LETTER OF SUBMITTAL
KFM Skyway Project # 04-012024

Subject: USI - Documents Clearing USI KFM NCR #24 (USI NCR 04-21)

Subject: Response to KFM-SUB-002140R00: USINCR 04-21

Subject: Response to KFM-SUB-002140R01: USI Documents Clearing USI KFM NCR #24 (USI NCR 04-21)

ASSY PA57

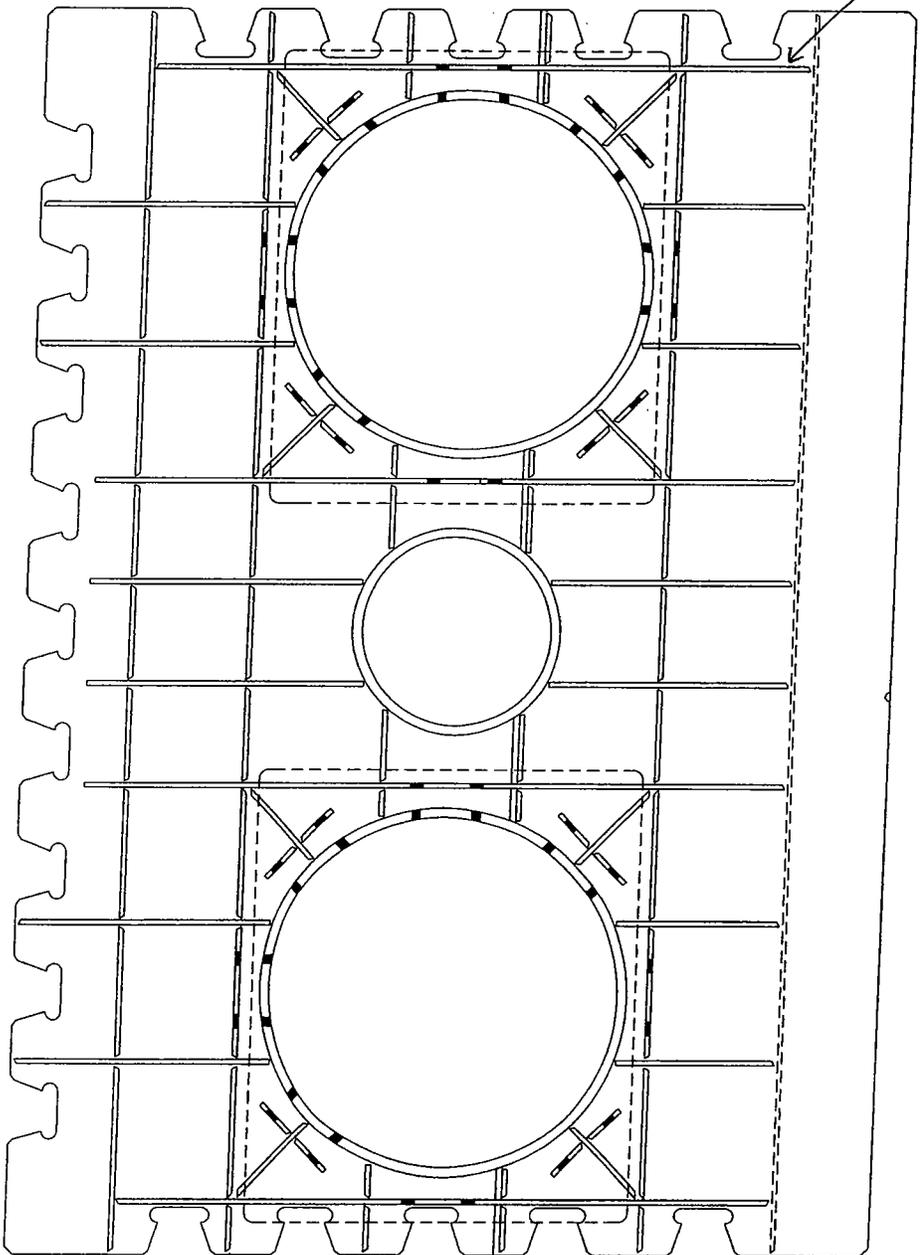
The Engineer has reviewed KFM-SUB-002140R01: USI Documents Clearing USI KFM NCR #24 (USI NCR 04-21). The subject submittal does not contain sufficient information to resolve the NCR. The Engineer understands heat straightening has already been completed on this piece. As such, please include a sketch showing where each application of heat was applied to resolve the NCR or inform the Engineer where this information may be found at **USI**.

* HEAT WAS APPLIED 500mm. down
FROM THE TOP OF STIFFENER PIS5b ALL
THE WAY TO THE BOTTOM OF PIS5b.
